# **Review of Fonterra's 2020/21 base milk price calculation: Dairy Industry Restructuring Act 2001**

## **Final report**

**Date of publication:** 15 September 2021

**Figure 2: CEPA's flowchart on the SRP<sup>64</sup>**

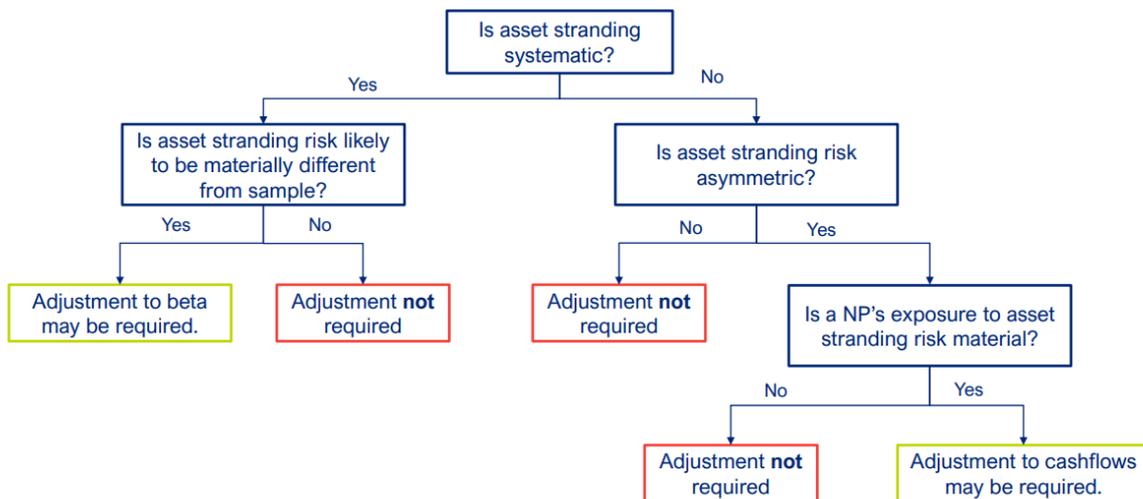
3.70 CEPA's advice on the SRP includes a useful flow chart (reproduced in Figure 2 below) that can assist in answering the question of whether a SRP should be applied.

**Figure 3: 10-year view of total NZ milk supply and Fonterra milk supply scenario**

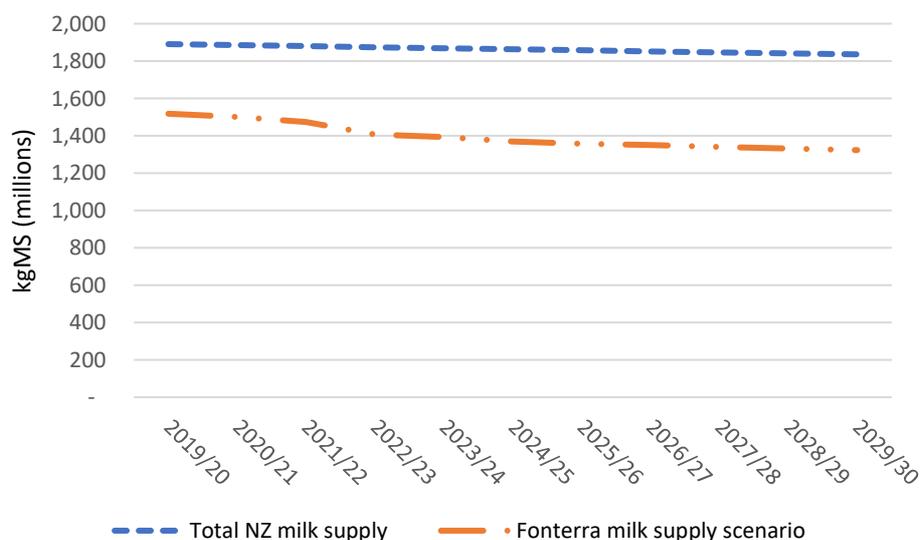
- 3.98 Figure 3 below shows Fonterra's outlook of total NZ milk supply over the next 10 years, overlaid with a potential declining milk supply scenario presented by Fonterra in its recent Capital Structure consultation booklet, under which Fonterra's supply could fall to 1,300m kgMS by 2030.<sup>73</sup> As described in paragraph 3.65 above, Fonterra can manage up to a 3% reduction of milk supply in the base milk price model by not replacing fully depreciated assets each year.

- 3.103 Our conclusion is that the non-systematic risk associated with reduction in milk supply volumes is low. This is because the Manual provides for up to 3% of plant capacity to be reduced per annum by not replacing fully depreciated assets. In this context an SRP value of nil is reasonable.
